**Welcome to the Technical Guidance Committee (TGC)
Meeting
June 11, 2026
9:30 a.m. (MST)**

Idaho Technical Guidance Committee (TGC) Meeting Agenda

Meeting Minutes

March 5, 2026

Coir/Peat Biofilter - Poly Tank

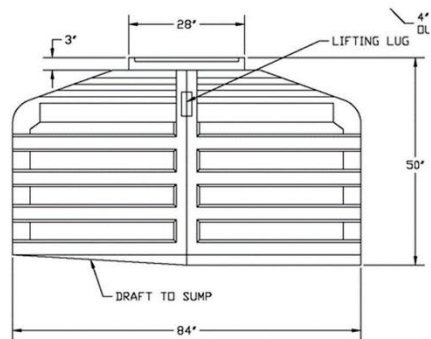
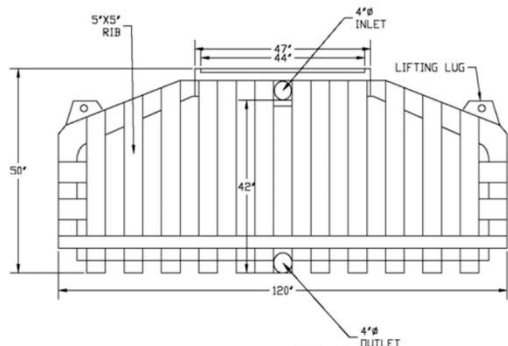
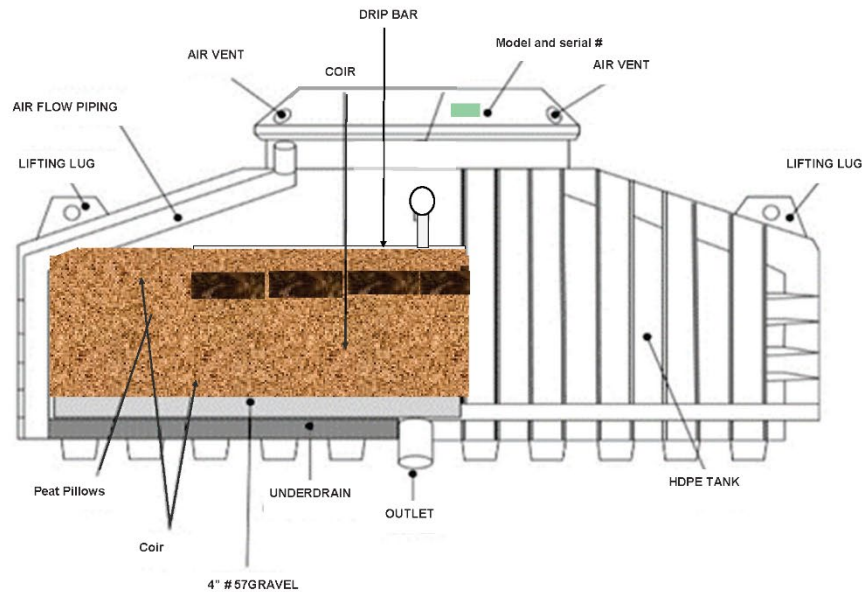
- Joe asked about commercial use if they would pump into it. Joe also asked about the diagrams on the cross-section, and if they are aeration pipes.
- Tom confirmed that it's a 4-inch cross-section, a collection manifold, and aeration to the manifold. He also said some precasters will use 1-inch clean aggregate to protect the manifold. Additionally, he said they've used false aggregate, polystyrene peanuts, and black pipe.

- Jason said in the manual on the diagram on the upper left, one thing we've learned is that any change that isn't confirmed before implementation receives questions. Jason asked if there were any proposed changes to the manual.

- Joe asked if the holes in the pipe are pointed down.
- Tom confirmed the holes in the pipe are pointed down.
- James said the type of lid would also be a callout.
